From: drainage <drainage@midsussex.gov.uk>
Sent: 26 August 2025 17:39:49 UTC+01:00
To: "Tracie Axford" <Tracie.Axford@midsussex.gov.uk>
Cc: "drainage" <drainage@midsussex.gov.uk>
Subject: 2025.08.26 Re: DM/25/1855 - 65 Cuckfield Road Hurstpierpoint Hassocks West Sussex BN6 9RR

Thank you for consulting the Flood Risk and Drainage Team on the above application.

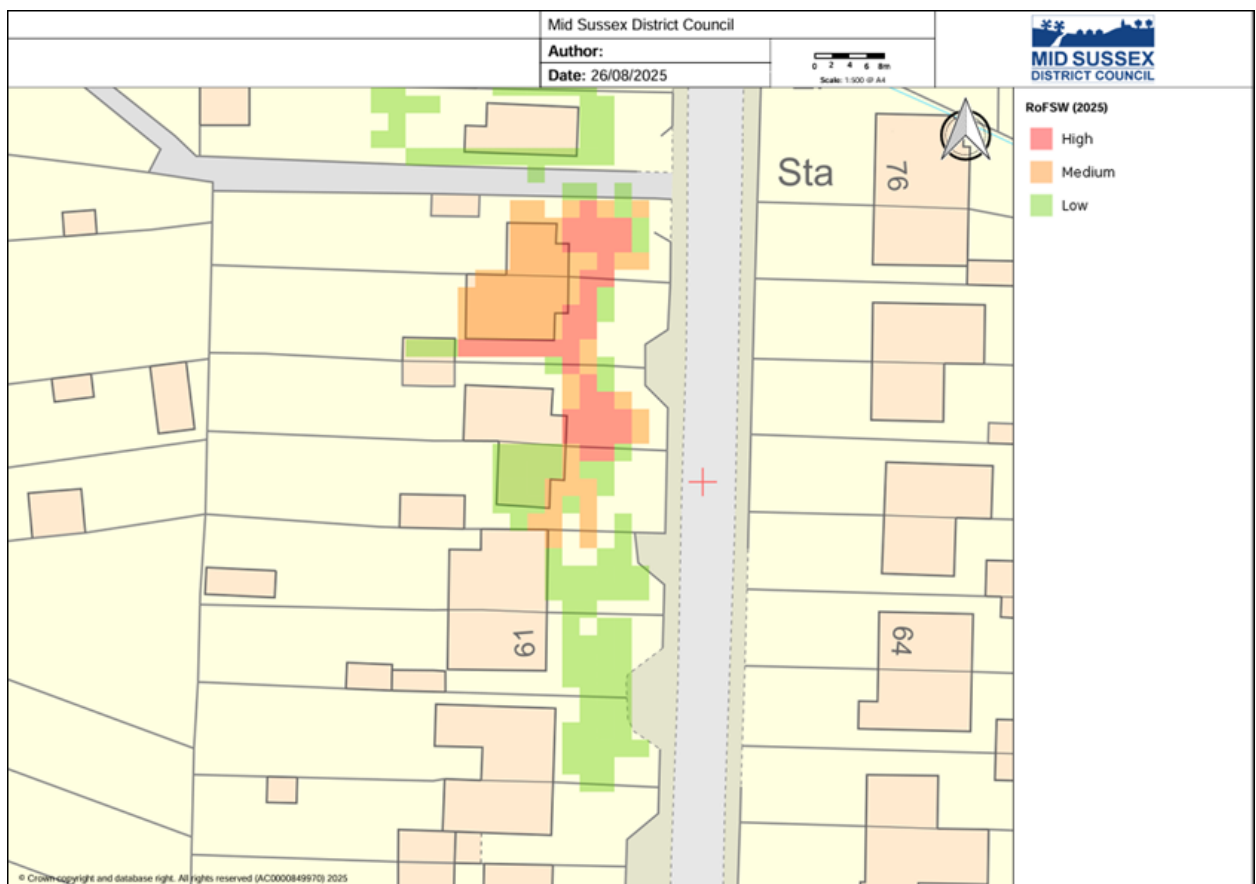
The updated Risk of Flooding from Surface Water mapping released in March 2025 shows the proposed development site is located within an area impacted by High, Medium and Low surface water flood risk. Following the approach set out under the NPPF for assessing fluvial flood risk (flood zones) this area would be considered consistent with Flood Zone 3b, 3a and 2.

As per the Environment Agency standing advice for minor extensions, development within the 1:30 (3b) flood extent is not permissible. In the event that the proposal is outside of this extent, then additional resistance and resilience mitigation will need to be evidenced at this location, as this development is classified as 'more vulnerable'.

In addition to a Flood Risk Assessment, we would advise that the applicant provide an overlay of their proposed block plan on the above screenshot (or equivalent) of the 1:30 flood extent is required at this stage of planning in order for us to review any encroachment.
